ADDENDUM NO. 2

23 January 2017

RE: MILLER PARK DISTRICT PHASE 1
Contract no. R-14-011-201

FROM: Spackman Mossop Michaels / Eskew+Dumez+Ripple, Joint Venture
365 Canal Street, Suite 3150
New Orleans, Louisiana 70130
(504) 561-8686

Sheet No: L2.2

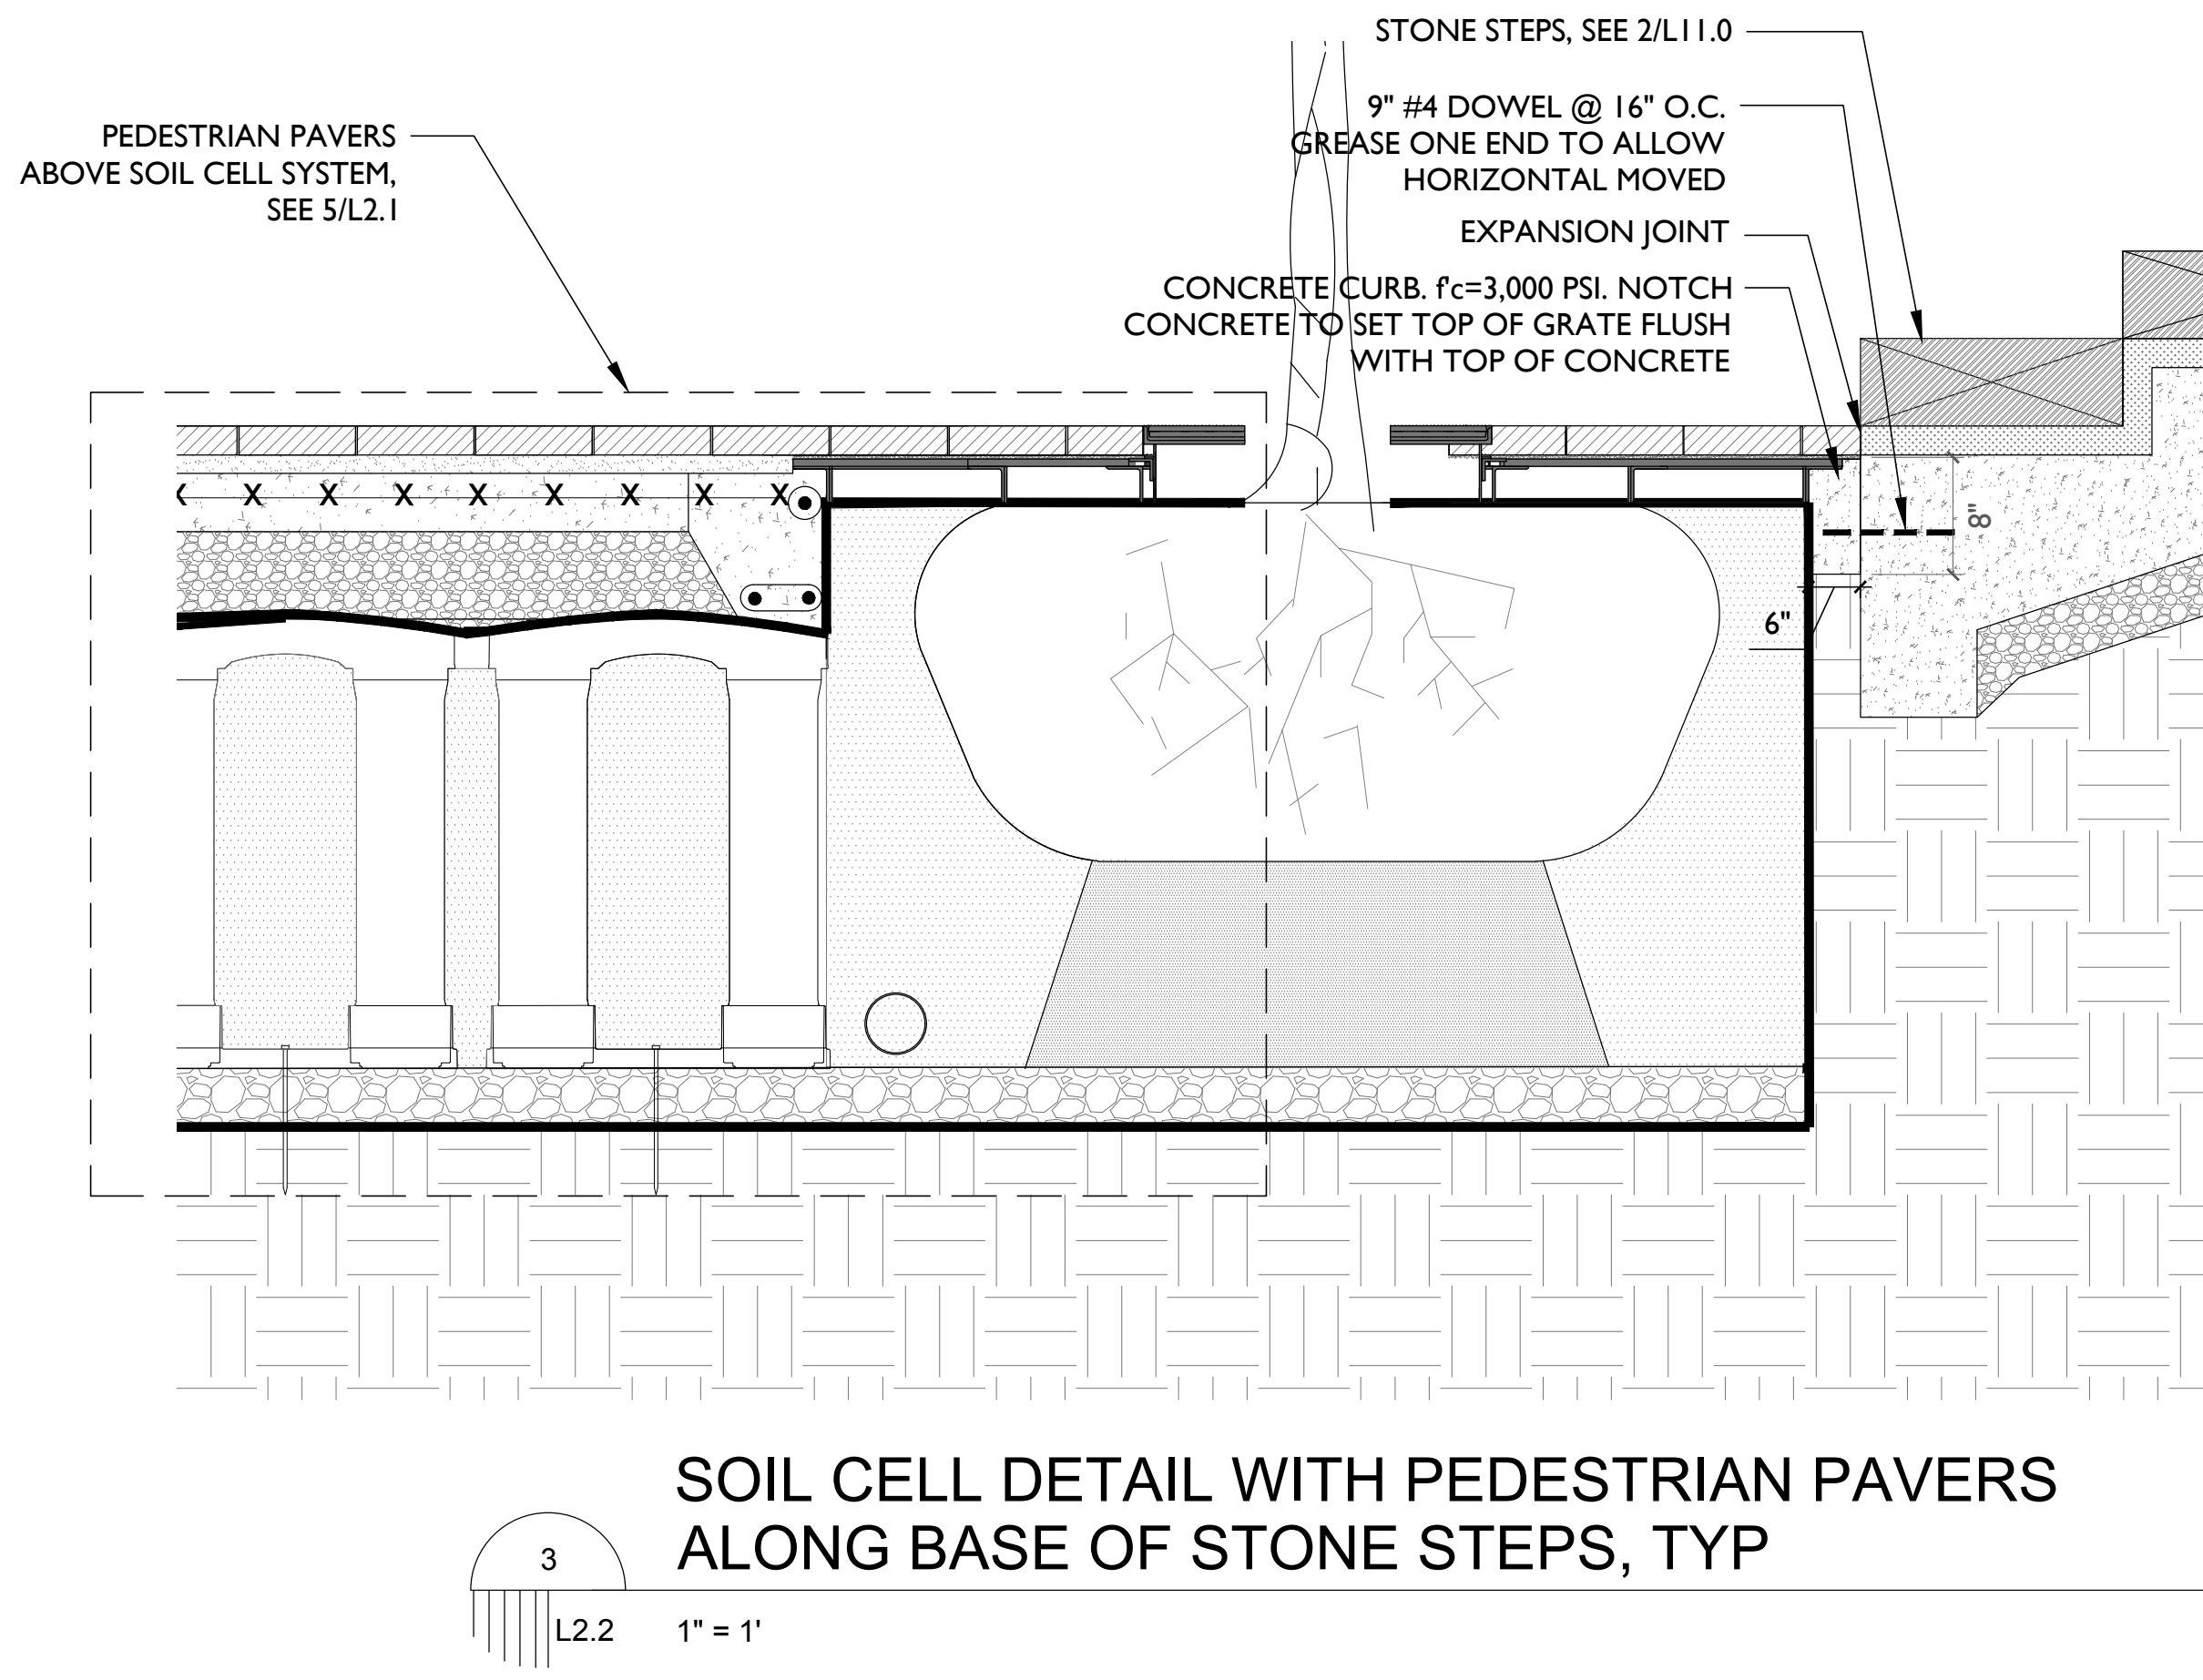
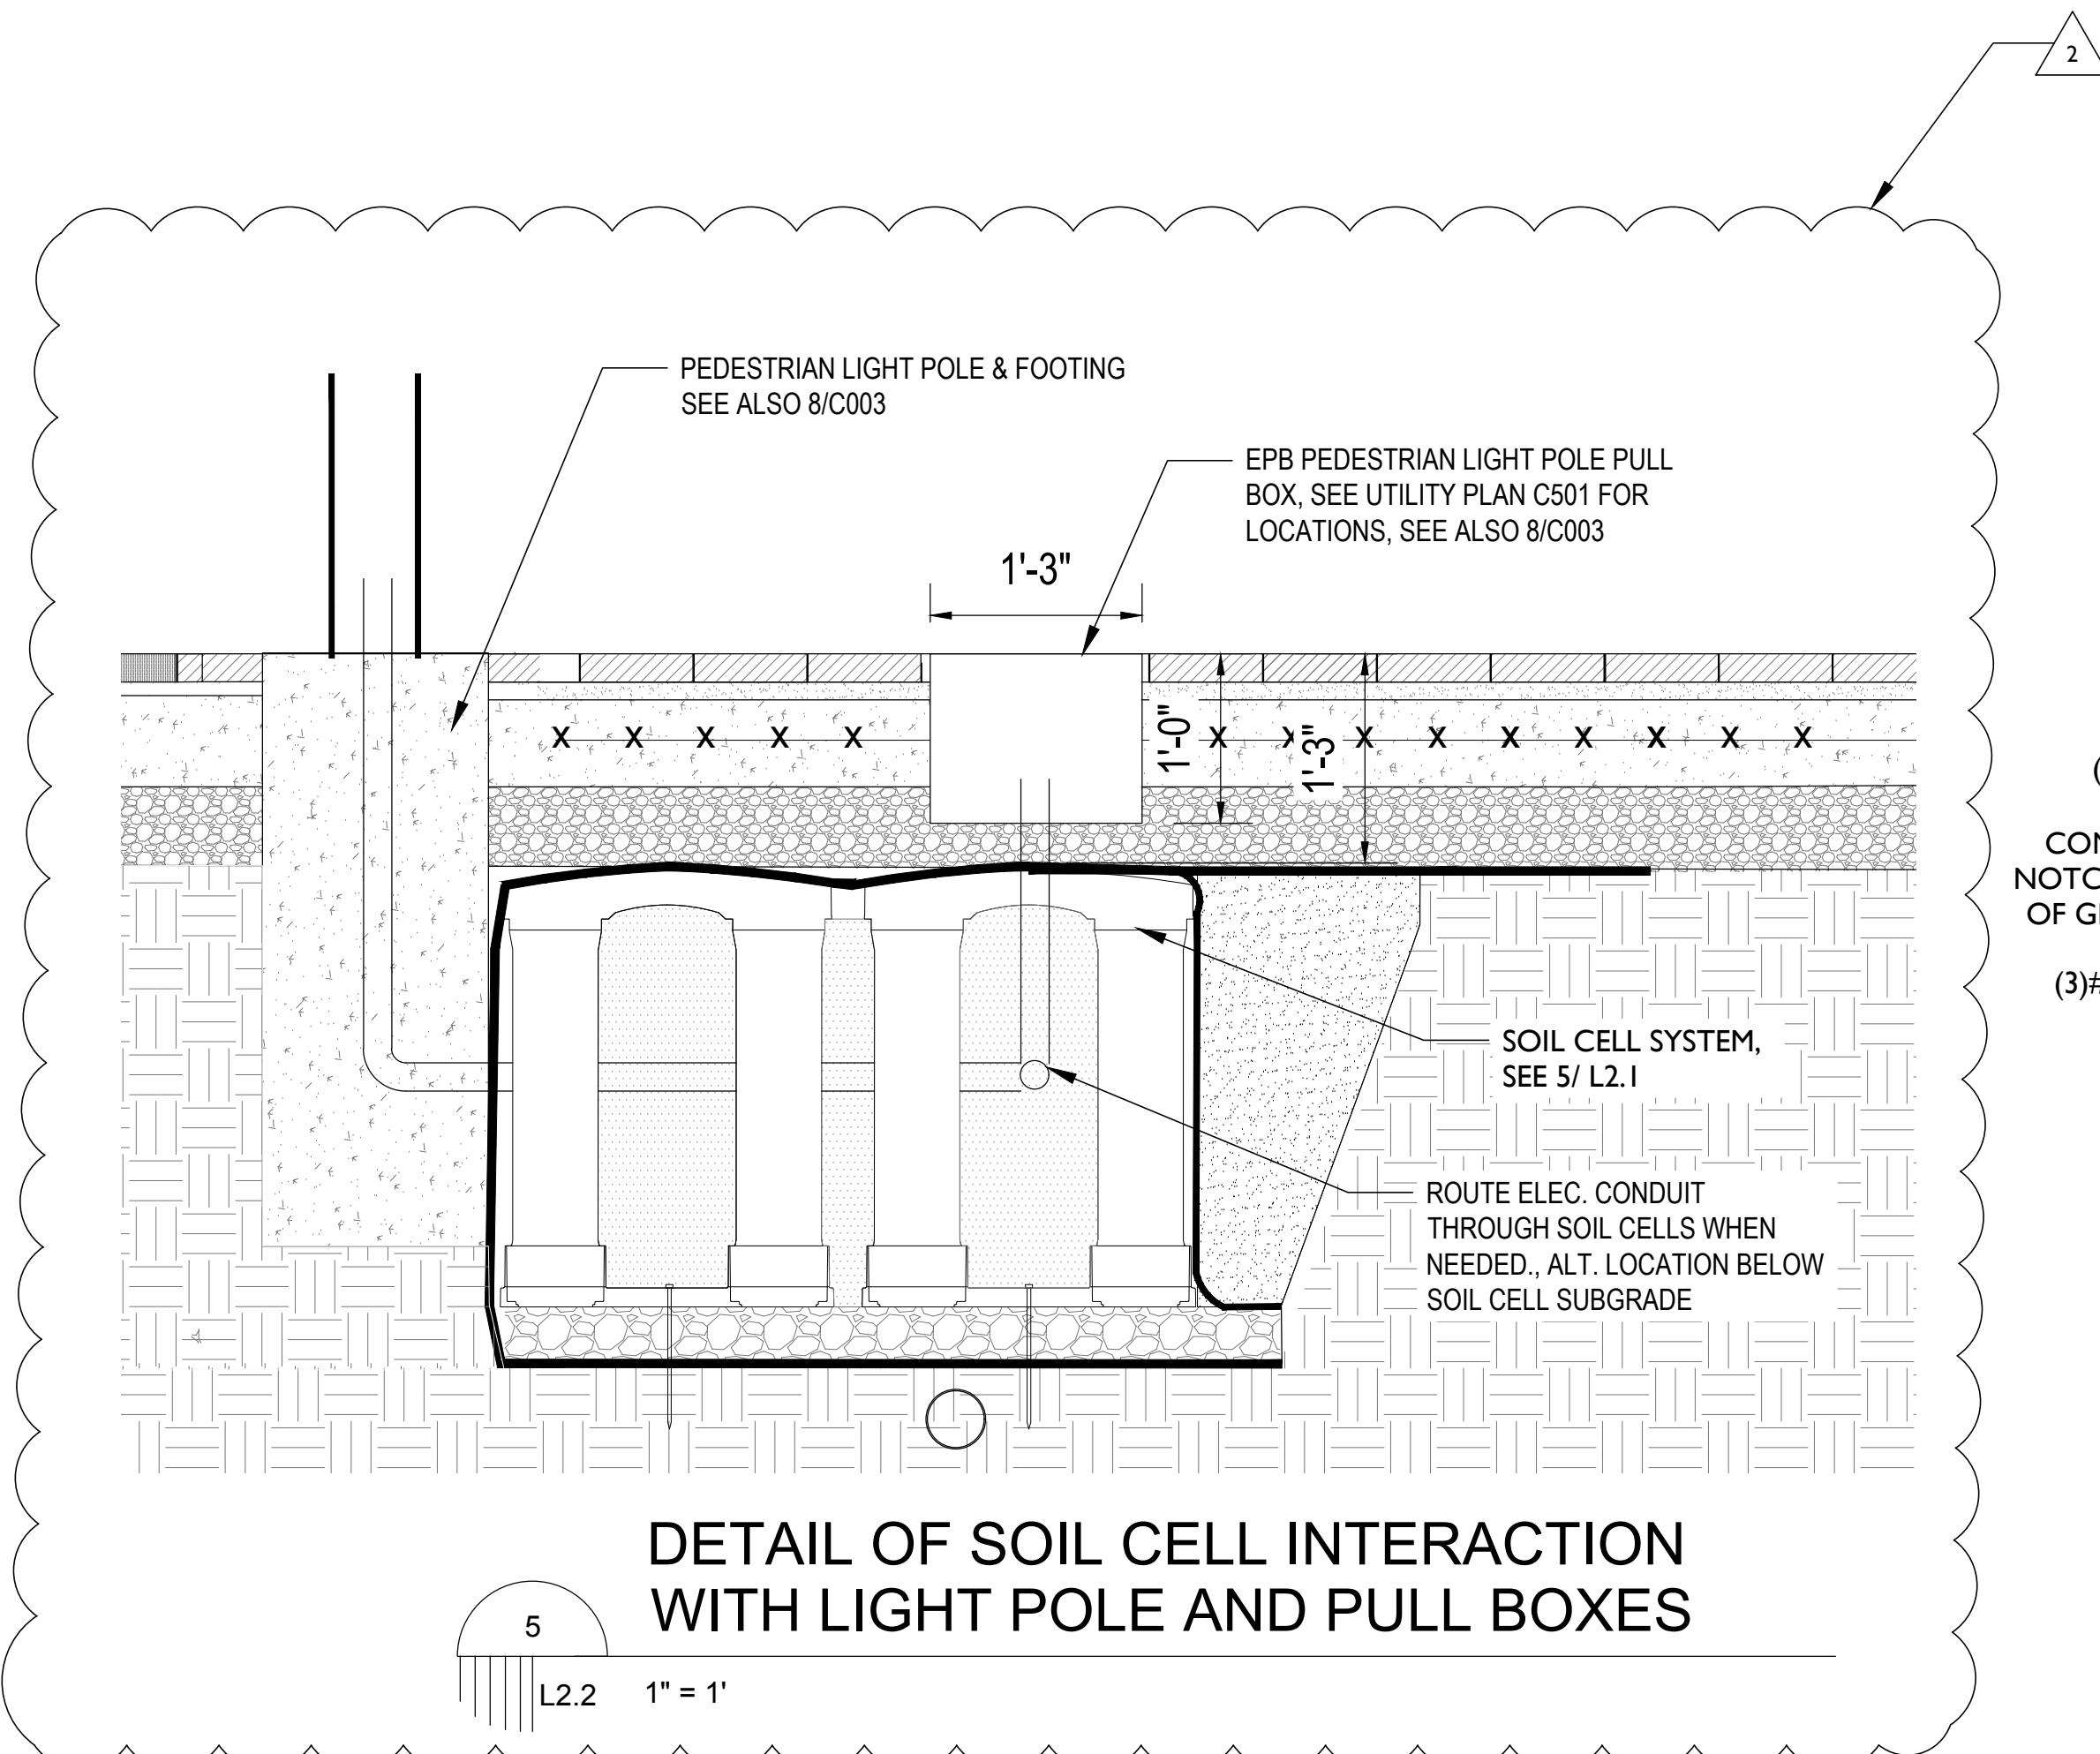
- P. L2.1- SOIL CELL DETAILS: Added title block to sheet.
- Q. L2.2- SOIL CELL DETAILS: Added 6/L2.2: Detail of Soil Cell Interaction with Light Pole and Pull Boxes.
